CITY OF FORT LAUDERDALE

# DEVELOPMENT REVIEW COMMITTEE

## CASE COMMENT REPORT

<b>CASE</b>	UDP-S25059
<b>PROJECT NAME</b>	Sanctuary Village Mixed-Use Project
<b>APPLICATION TYPE</b>	Site Plan Level II
<b>APPROVAL LEVEL</b>	Development Review Committee / Subject to Development Agreement by the City Commission
<b>REQUEST</b>	Pursuant to Section 166.04151(6), Florida Statutes: Mixed-Use Development with 348 Multifamily Residential Units, inclusive of 111 Affordable Units, 6,200 Square Feet of Commercial Use, and 17,733 Square-Foot Church Program Building, Waterway Use, and Associated Site Improvements
<b>APPLICANT</b>	Presbytery of Tropical Florida, Inc.
<b>AGENT</b>	Nectaria Chakas, Lochrie and Chakas, P.A.
<b>PROPERTY ADDRESS</b>	1400 N Federal Highway and NE 14 Court
<b>ABBREVIATED LEGAL DESCRIPTION</b>	Portion of the N ½ of the SW Section of 36, Township 49 S, Range 42 E and Lauderdale Isles 26-17B, Lot 18, 19, 22 Block A
<b>ZONING DISTRICT</b>	Boulevard Business (B-1), Community Facility/House of Worship and School (CF-HS), Residential Single Family/Low Medium Density (RS-8) District

***Building Articulation, Building Corner Design, Materials***

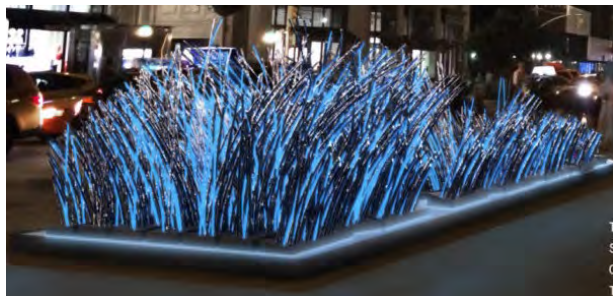
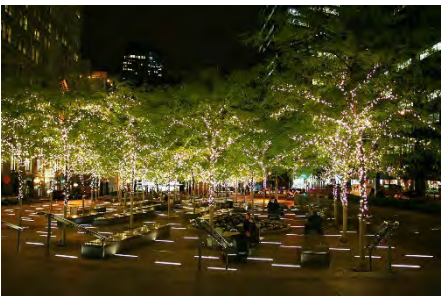
14. Provide the following changes to the elevations for the mixed use building. See design examples at the end of this comment report.
  - a. Line parking garage with habitable space. Where liner uses are not possible, ensure screening is made of high-quality, durable materials.

- b. Add setback on east façade to reduce impact of massing on waterway.
  - c. Add corner feature to northwest corner.
  - d. Add design features that distinguish the eastern portion of the building from the western portion and create the impression that there are multiple buildings.

**Parking Podium Screening**

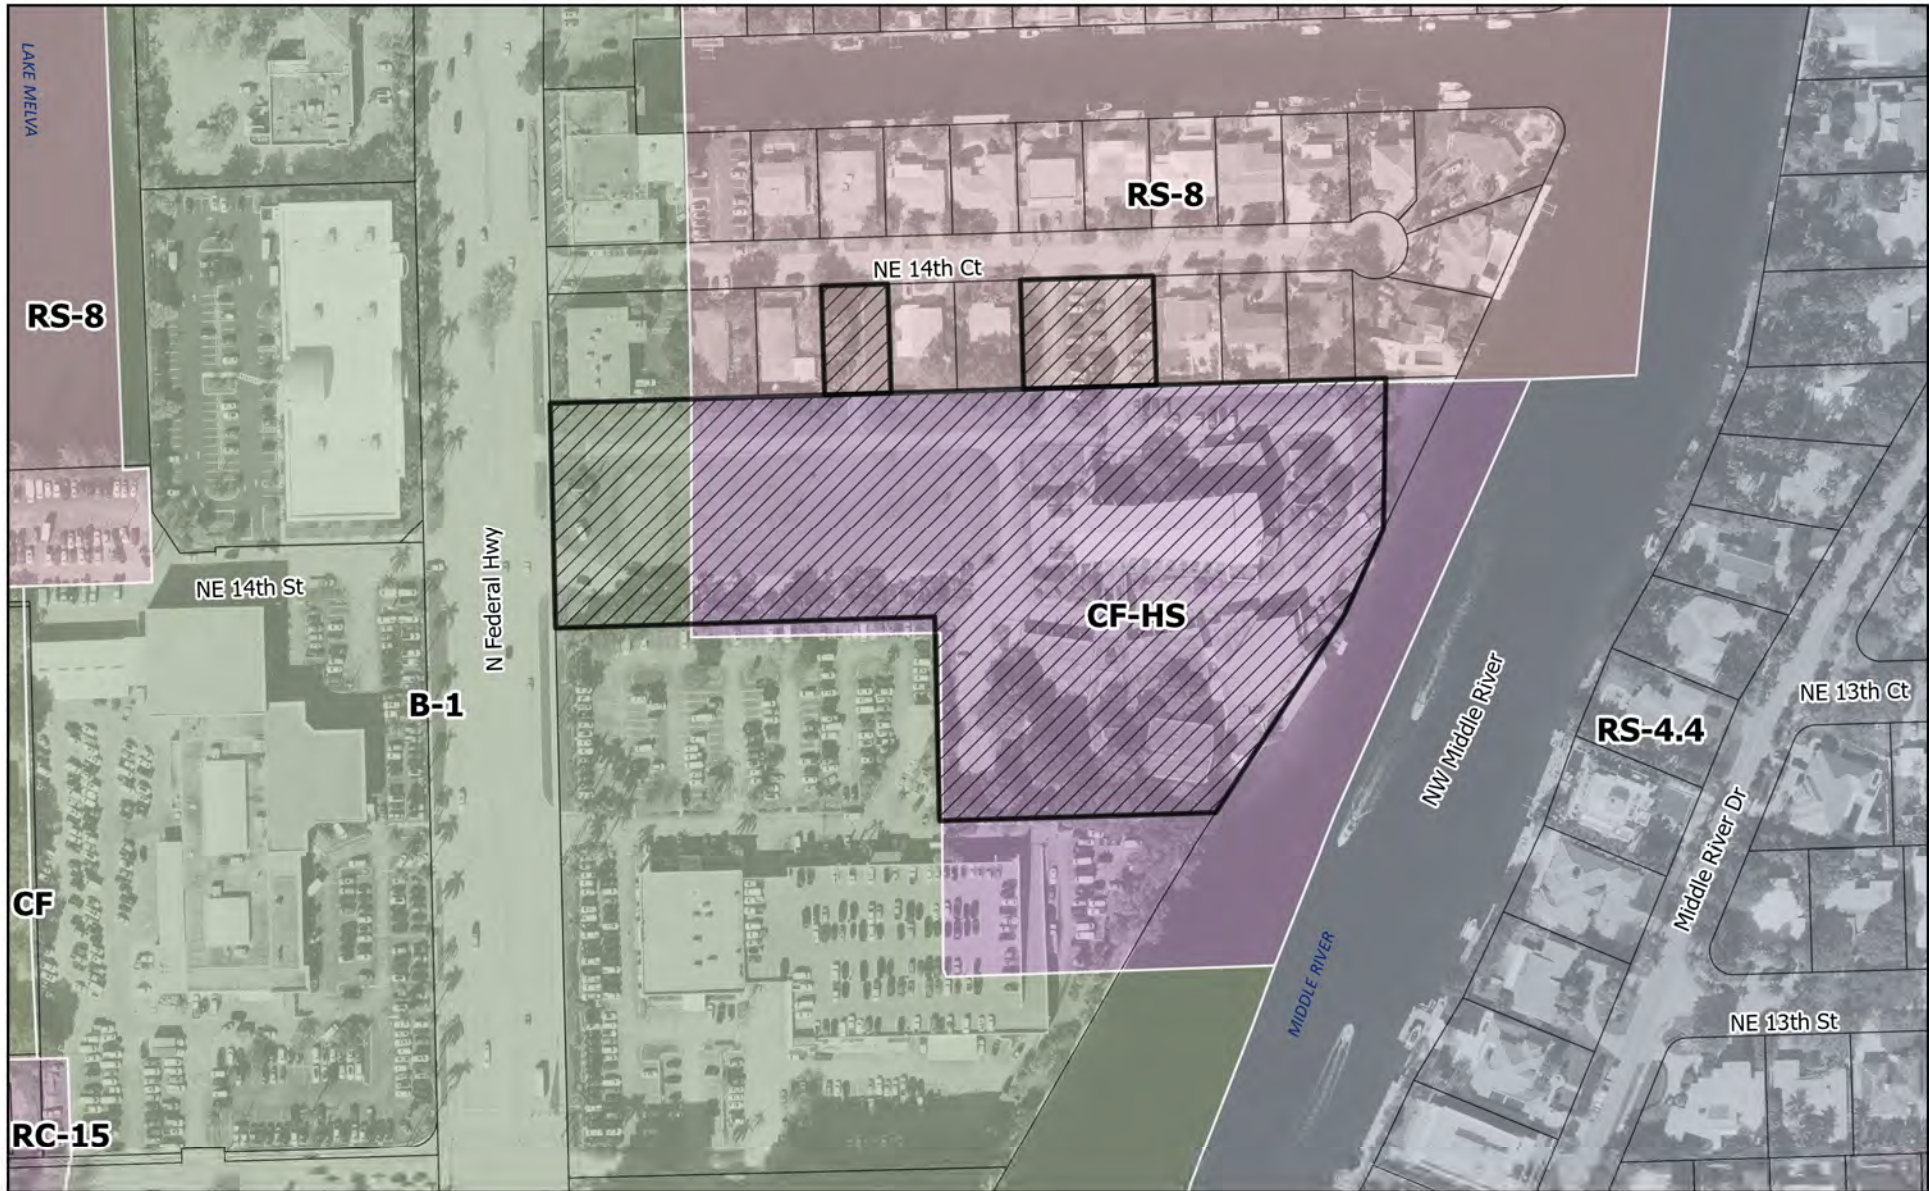
- f. Provide for linear pathway around the project for resident recreation use.
  - g. Provide site decorative elements along Federal Highway that create a sense of place such as creative pedestrian bollards, tree illumination, public art, etc. See image examples at the end of the comments.
